Development Engineering Formal Referral Response

Application Information	
Referral Officer	Katrina Thomas
Officer	Mark Pisani
Council Reference	NA
Address	9-13 Stewart Street, Richmond
Application No.	PA2201605 (DELWP)
Proposal	Referral - Internal – Development Engineering
Comments Sought	Development Facilitation Program

Figure 1 - Alignment of required outfall drain

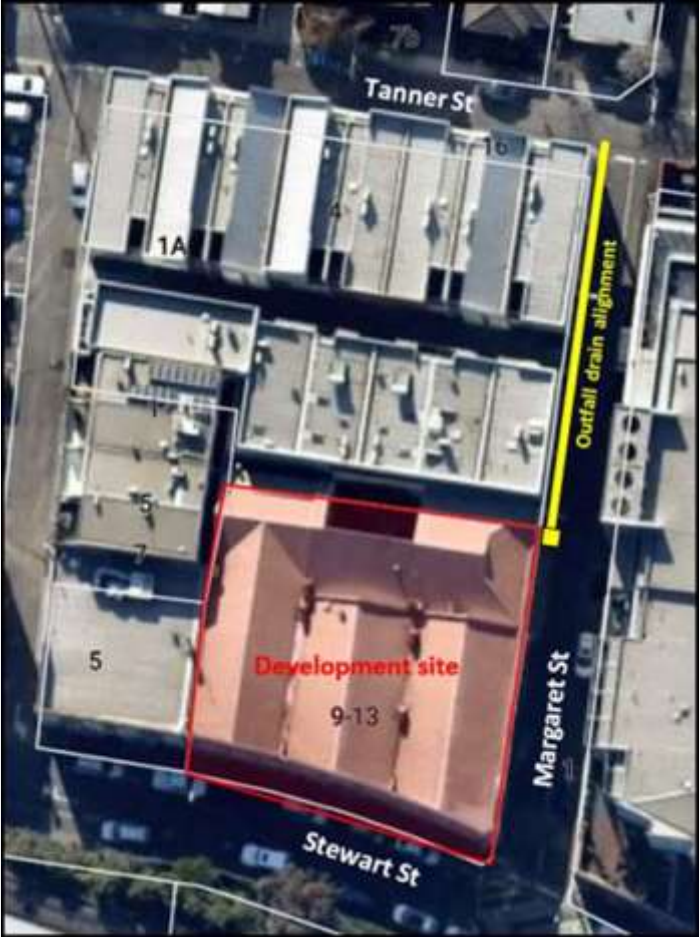
Provision of Underground Drain Extension Margaret Street

The applicant is to design and construct an outfall drain to direct the stormwater captured on site towards the drainage system located along Tanner Street.

The outfall drain must include a junction pit positioned back of kerb at the north eastern corner of the site, connected to Tanner Street via a drainage pipe along the western side of Margaret Street. See Figure 1 for details.

- The footpath along the site's Stewart Street frontage is to be profiled and re-sheeted to Council's satisfaction and at the Permit Holder's cost.
- An outfall drain is to be constructed from the north east corner of the site and extend along the west side of Margaret Street, connecting to the existing drain at Tanner Street to Council's satisfaction and at the Permit Holder's cost.
